ADDENDUM NUMBER 5

October 23, 2024

PROJECT: Africatown Welcome Center
1959 Babridge Cutoff Road
Mobile, AL
MM Project # 502100719

ARCHITECT: Mott MacDonald

NOTES:
a. REFERENCE CURRENT INSTALLATION INSTRUCTIONS FOR PROPER INSTALLATION PRACTICES.

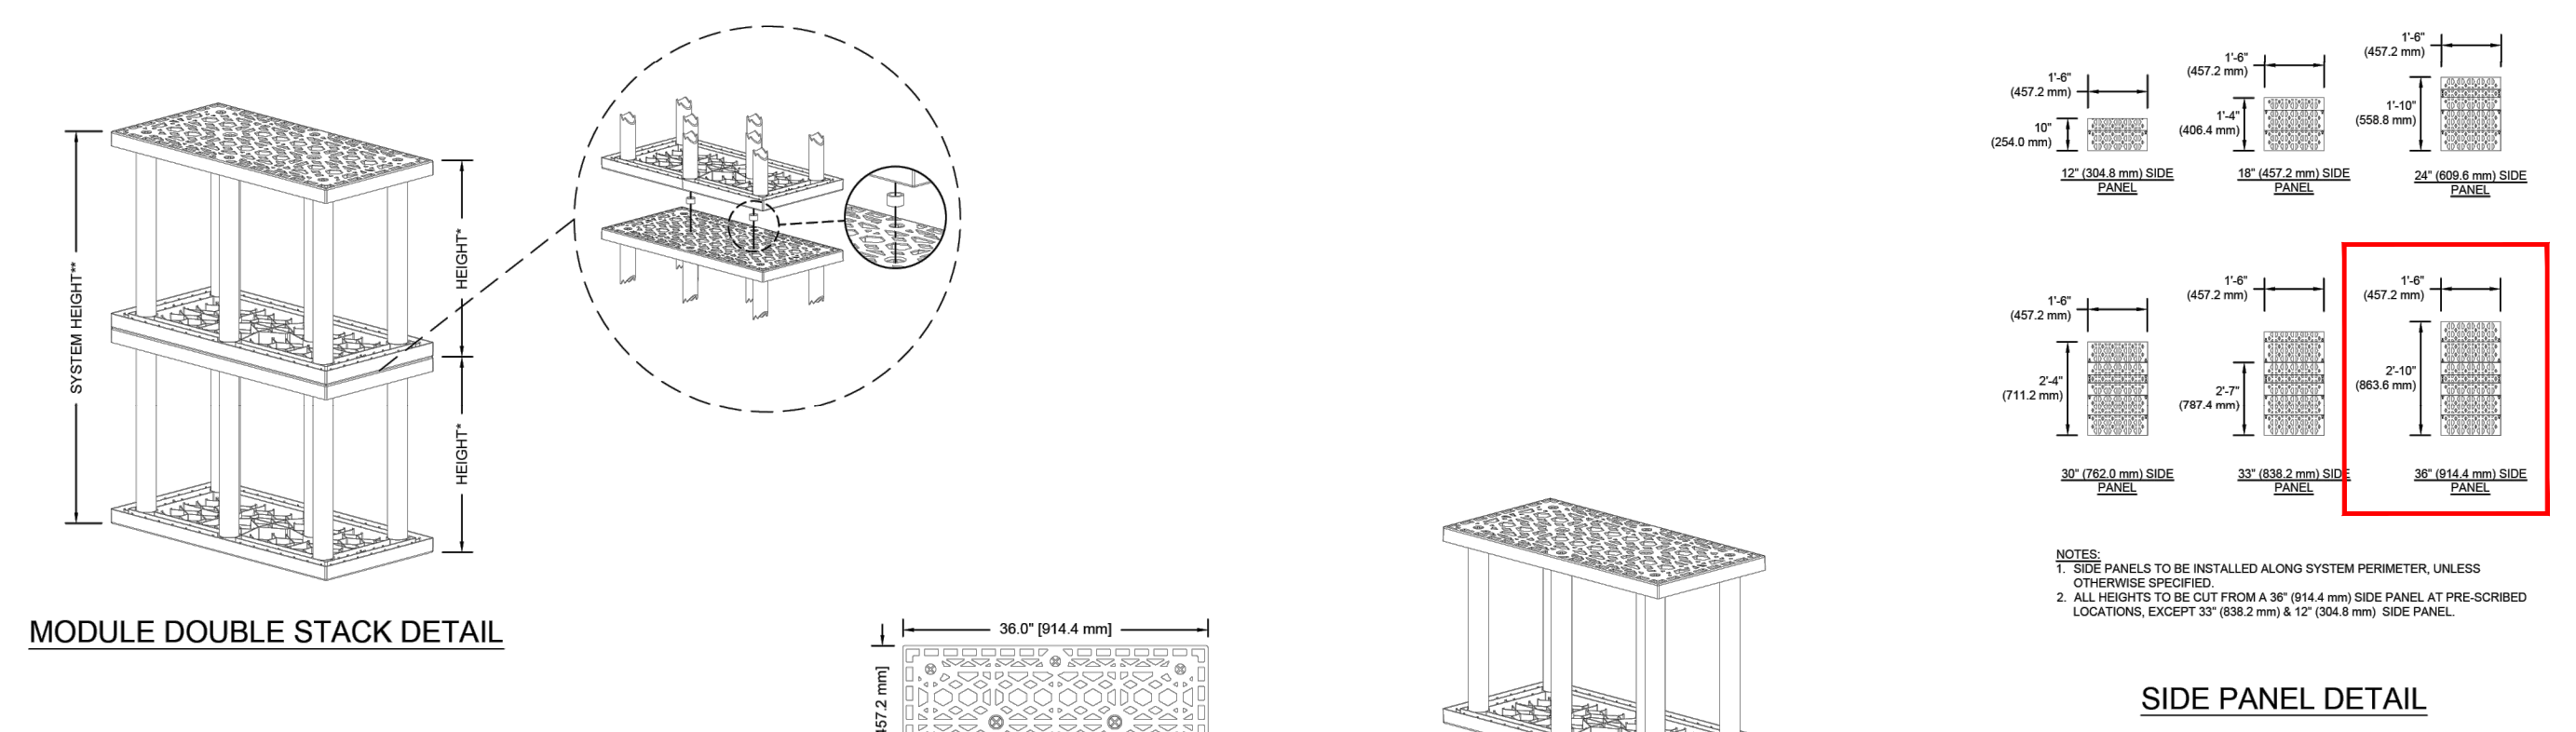
- a. Horizontals may be run continuous from door jamb to door jamb.
7. Please provide a detail sheet on the underground detention system.
 - a. See Updated Civil package (Attached).

01 NORTH TERRACE ENLARGEMENT
 1" = 10'-0"

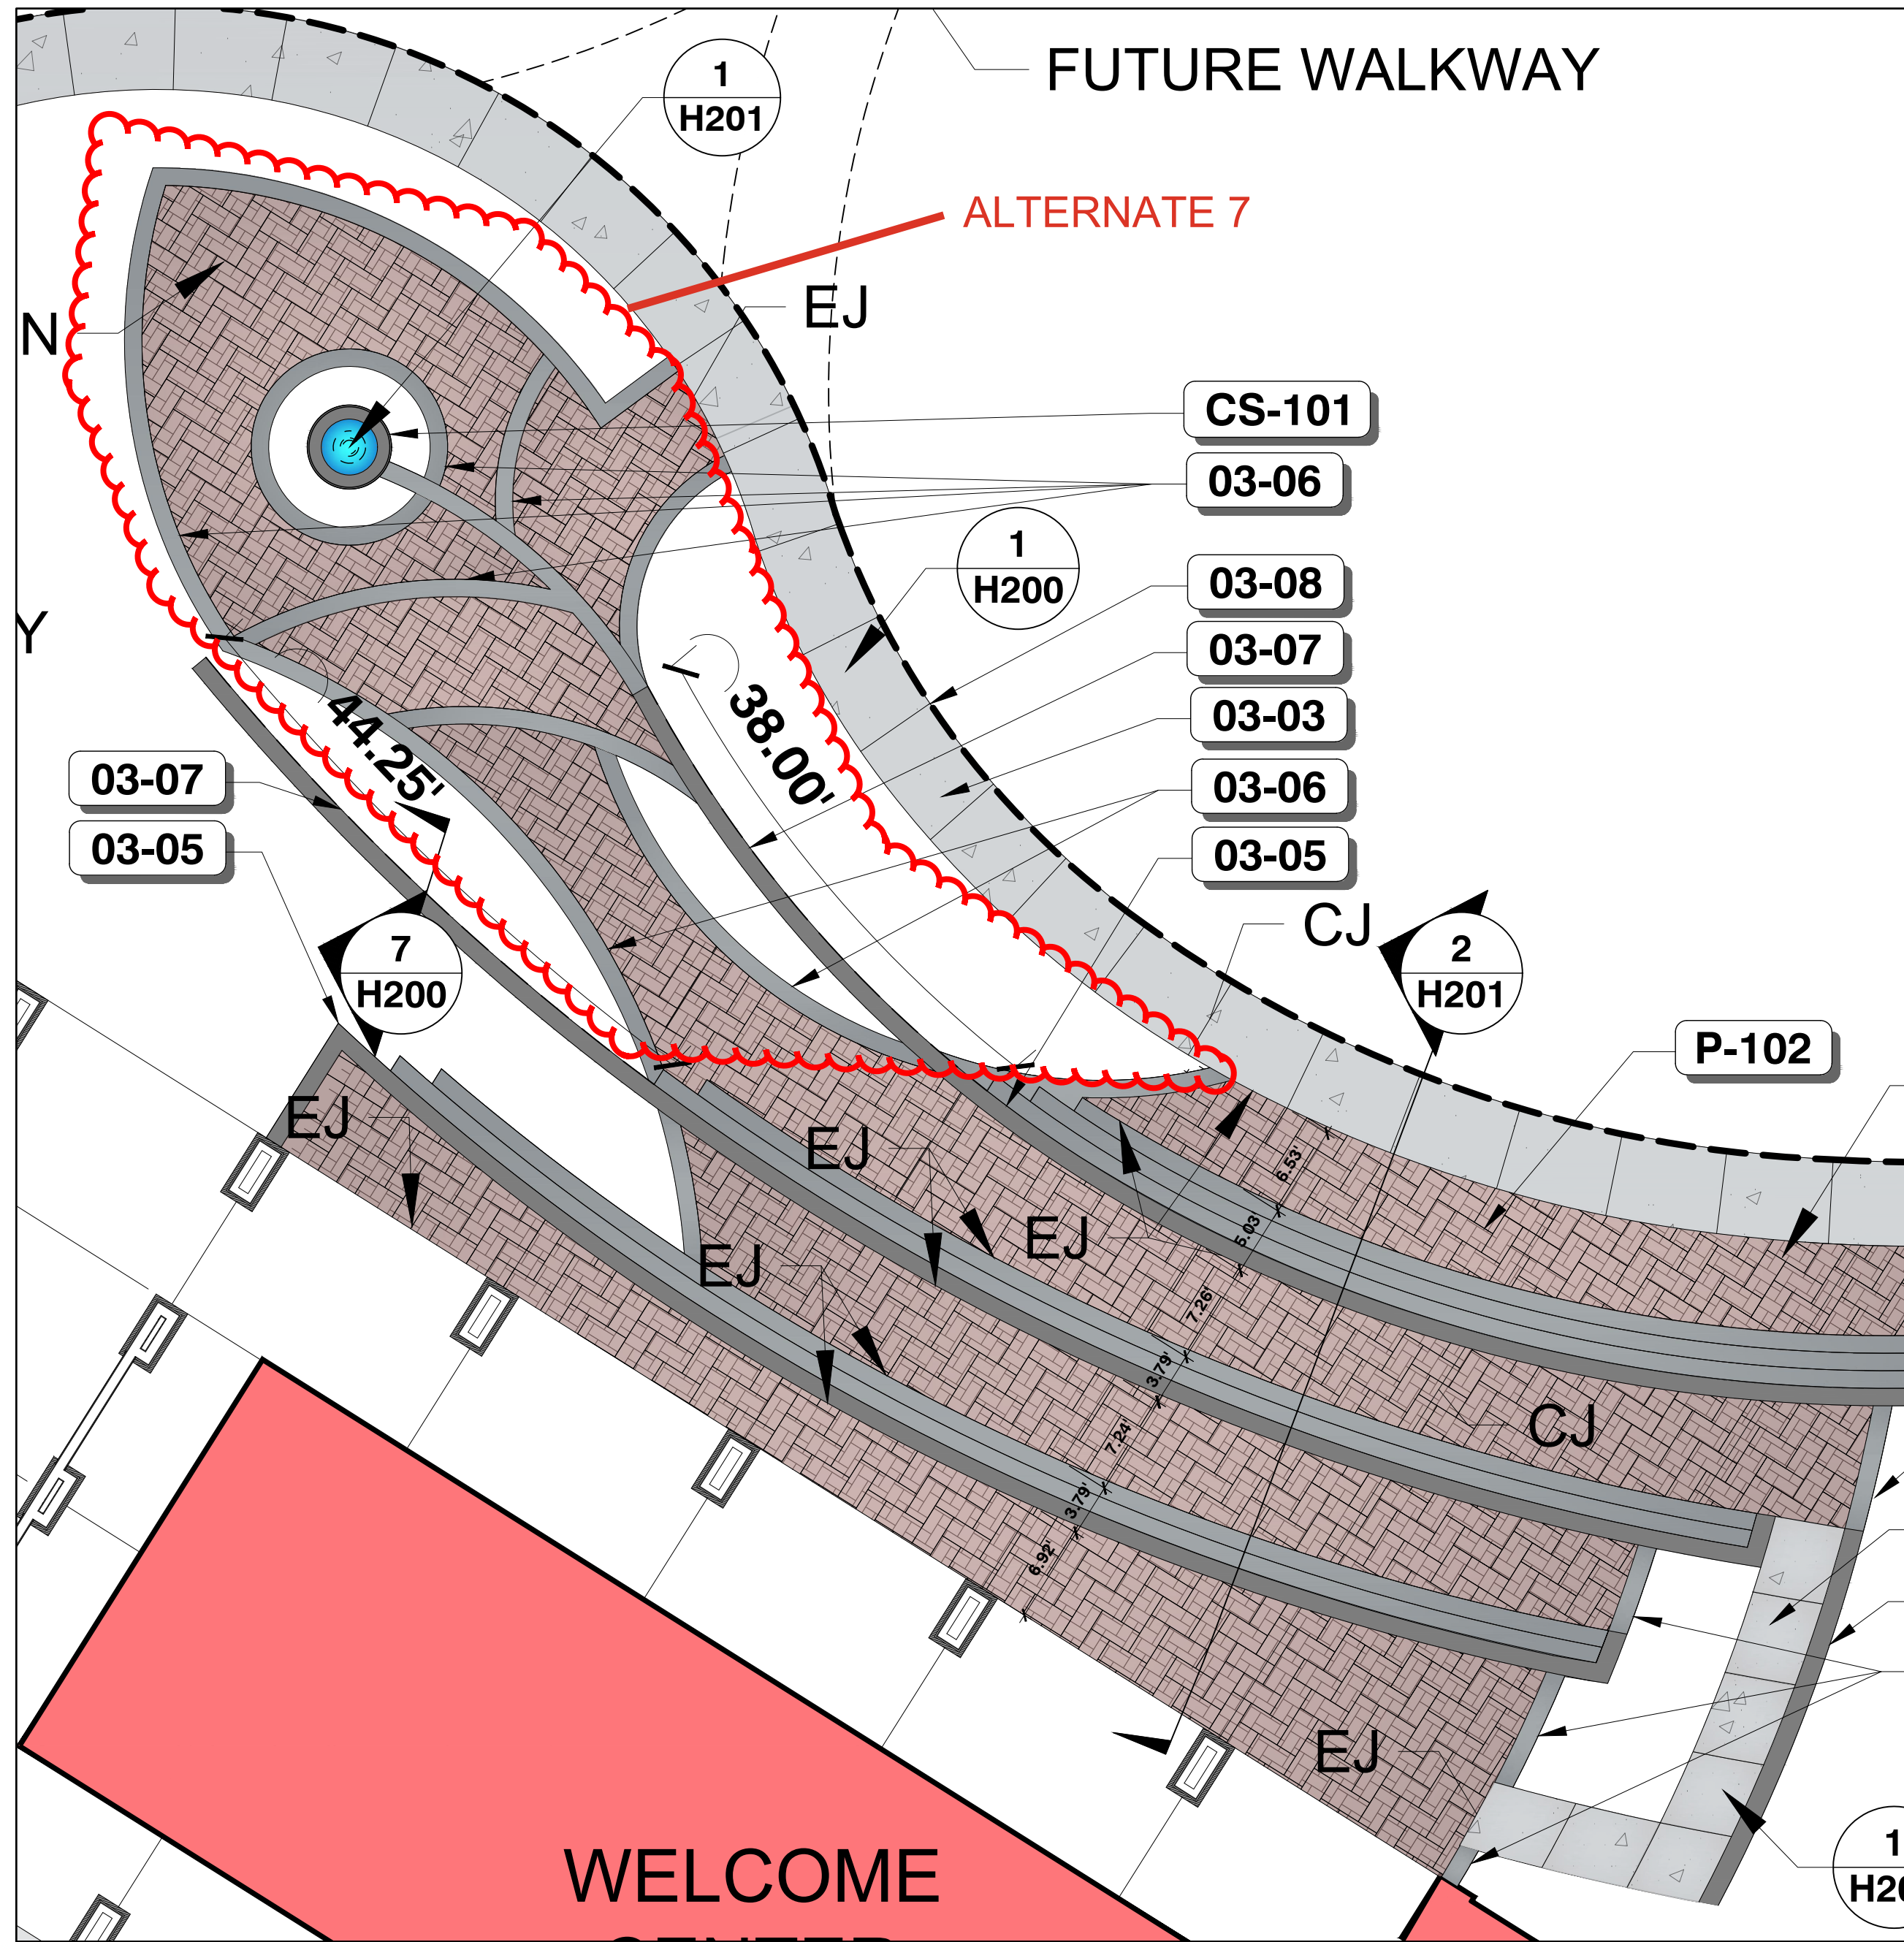
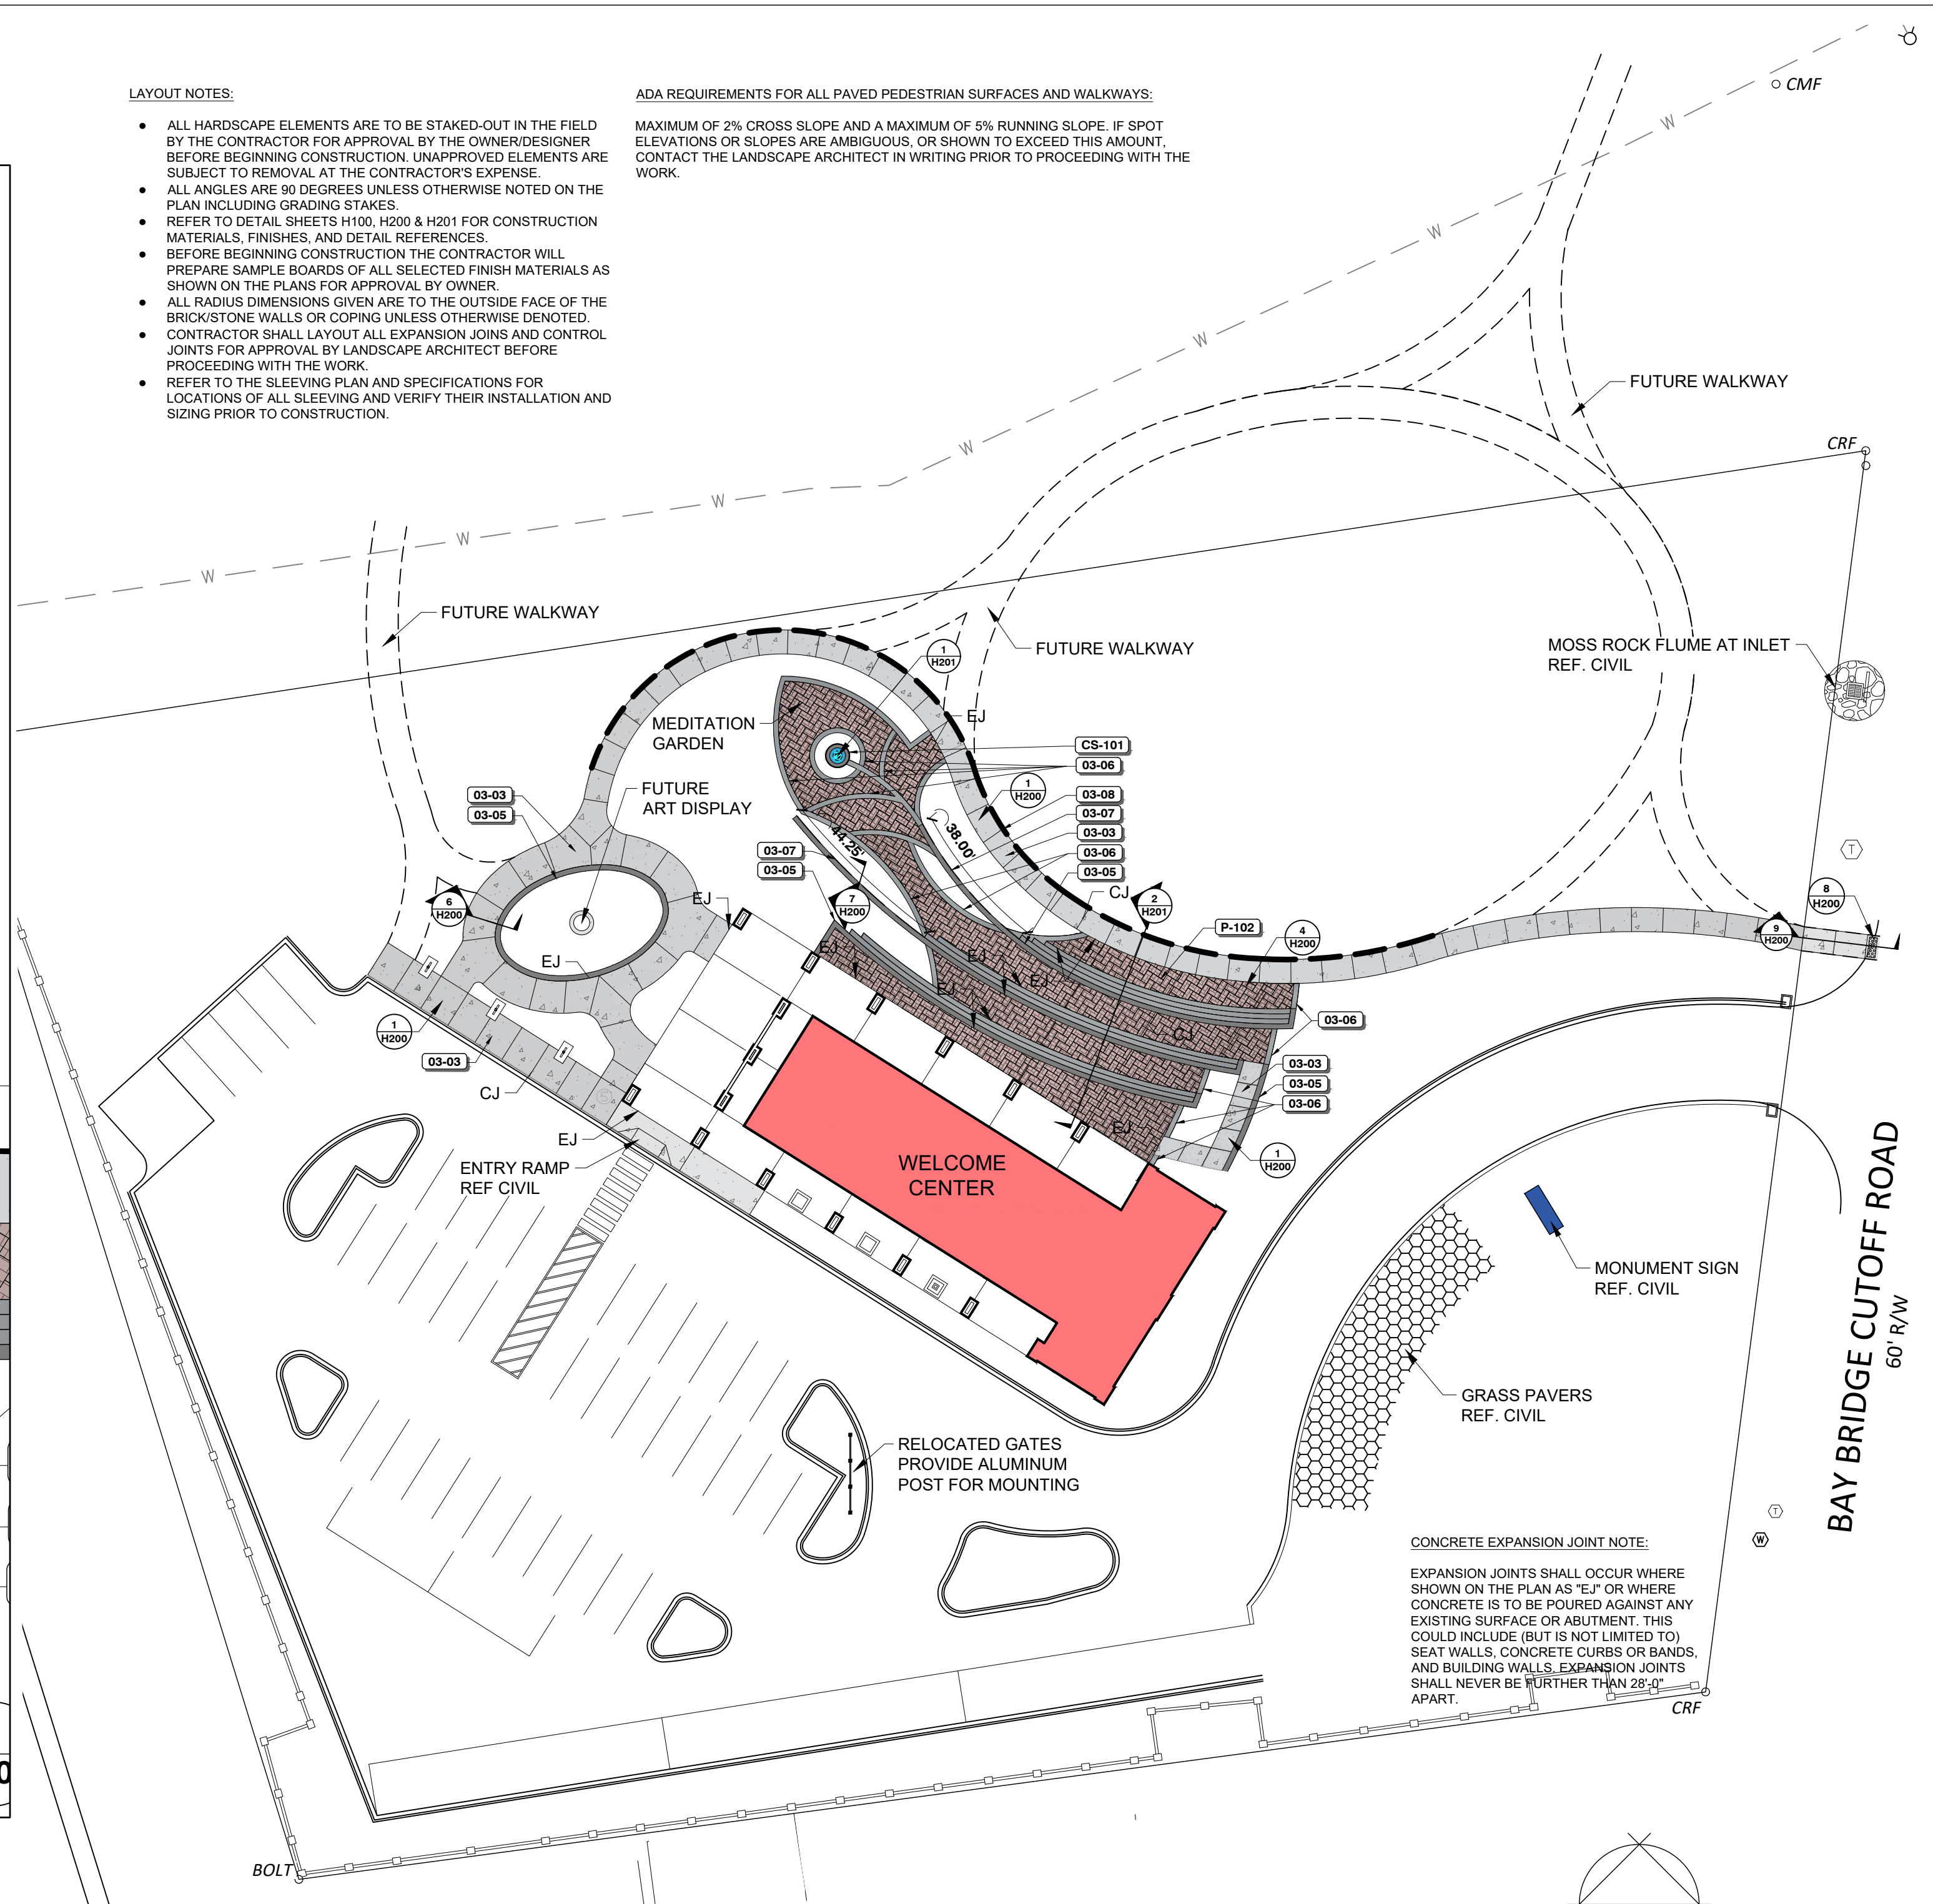
- a. See extents of Alternate 7 on attached sheet H100.
